NRC DOCKETS 50-321, 50-366
OPERATING LICENSES DPR-57, NPF-5
EDWIN I. HATCH NUCLEAR PLANT UNITS 1, 2
NRC I&E BULLETIN 80-11

NRC I&E BULLETIN 80-11, "MASONRY WALL DESIGN"

RESPONSE TO NRC REQUEST FOR
ADDITIONAL INFORMATION

EDWIN I. HATCH NUCLEAR PLANT

Project	HATCH - UNIT NO. 1 & 2	Prepared By	TINA C. SALSER	Date	11-17-80
Subject/Title	WALL MODIFICATION	Reviewed By	K. L. WILSON	Date	11-19-80
	C-112 - 1A & 1B (PSOC-80-001)	Calculation Number		Sheet	1 of 4

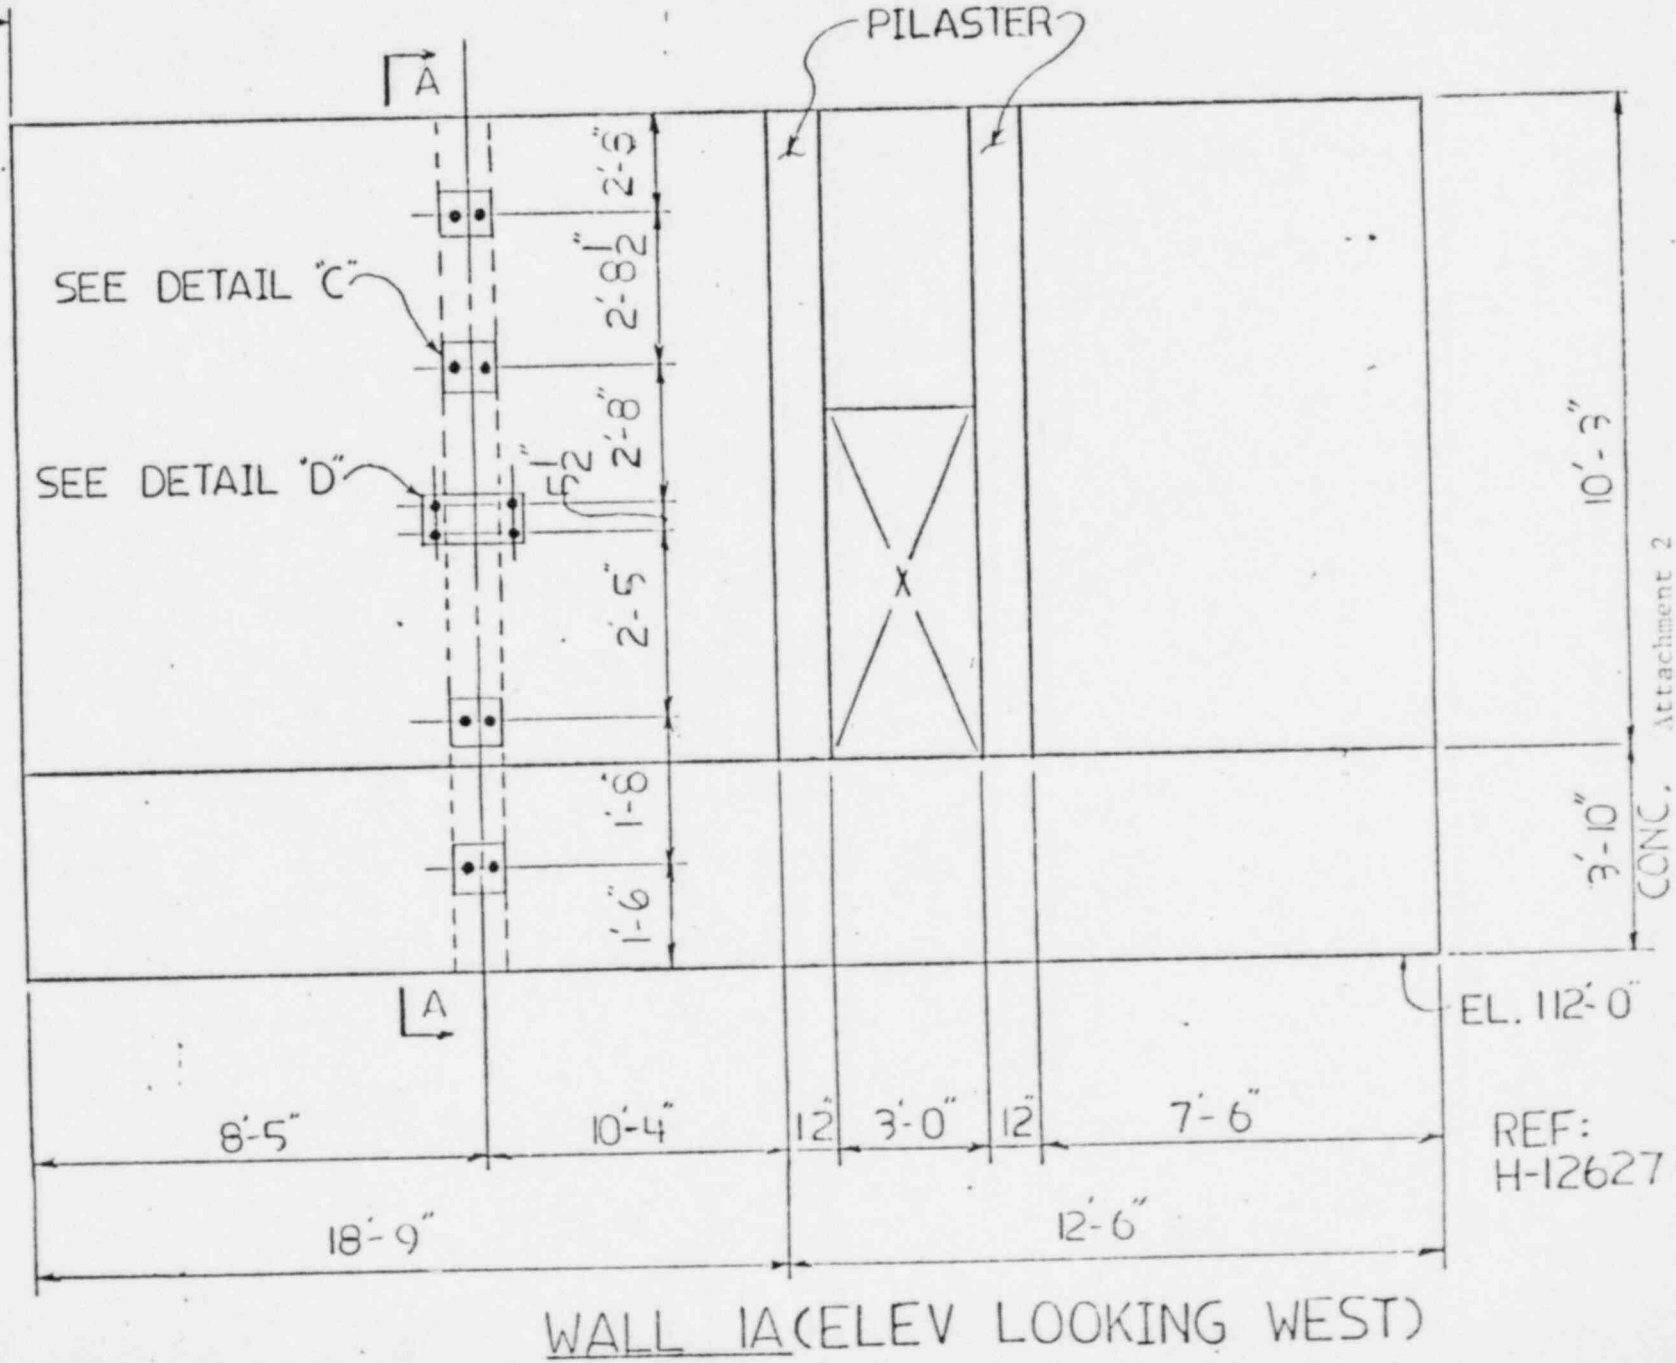
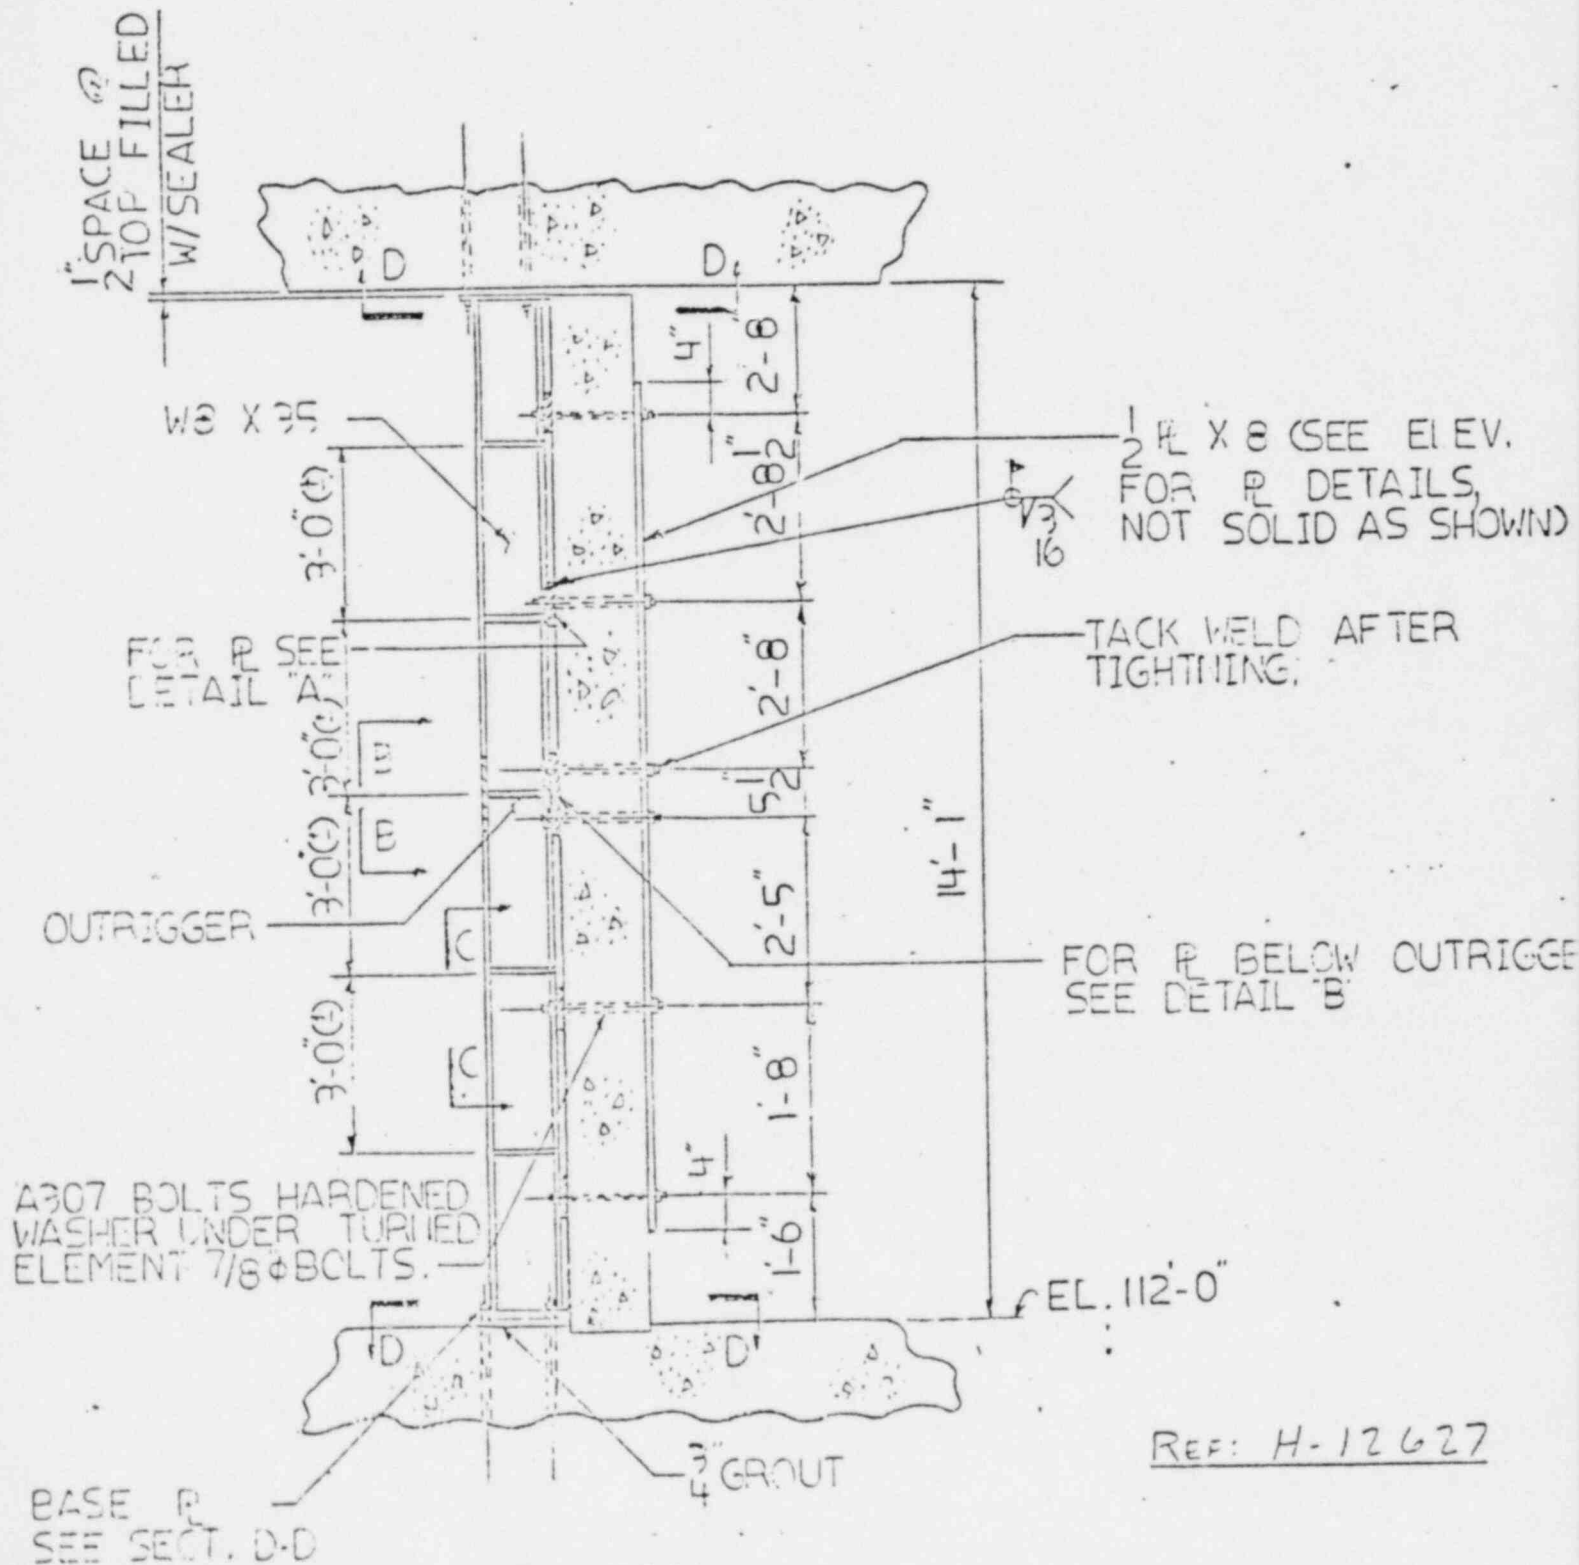
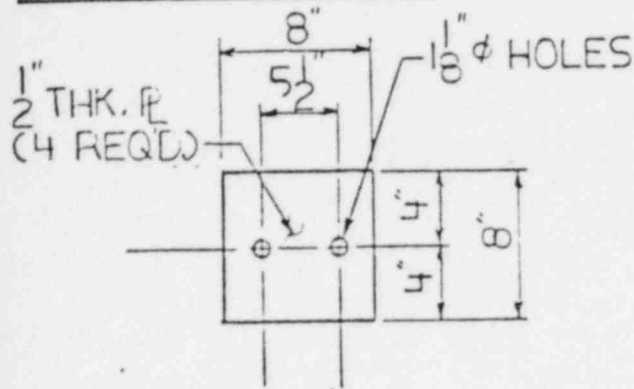
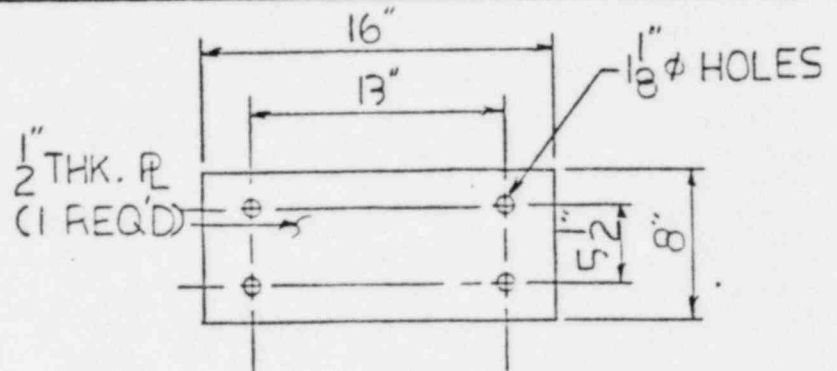
Provide details of modifications for all walls that do not satisfy the design allowables. Technical discussion should be provided detailing how these modifications will correct this deficiency. Also, provide the modification schedule.

A number of walls were modeled for STRUDL-DYNAL and had a finite element analysis run of the as-built condition, taking into account all loads and load combinations. A total of ten (10) walls were identified where calculated stresses exceeded allowable stresses. The results of the analysis showed that the effective horizontal span length of the wall should be reduced. Therefore, a point somewhere within the middle one-third of the span of the wall was chosen considering obstructions and installation problems, and one or more structural steel columns were erected to provide additional support for the wall. The column(s) were designed to withstand the applied loads and were used to brace the wall as shown in the attached sketches. The wall was then re-modeled for STRUDL-DYNAL, including the steel column, and a finite element analysis was performed again for all postulated loads and load combinations. Resulting moments and shears for the masonry wall and support column were checked against allowables. In addition, bolts, plates, and welds for the support having an angle brace were checked for worst-case loads. Wall number C130-14A&B had an angle brace attached to the ceiling on each side of the wall to provide lateral shear support and reduce a local overstress condition to within allowables. Following the analysis using the modified models, each wall was determined to satisfy all stress allowables.

Detailed sketches of the modification for each wall are shown in attachments 1 through 8. The field modifications for each wall are complete except for wall C164-4A&B and wall C130-39A&B. Both of these walls will be removed in the near future to allow for relocation of the shift supervisors office and modifications in the health physics area. Therefore, no modifications have been scheduled for these walls.
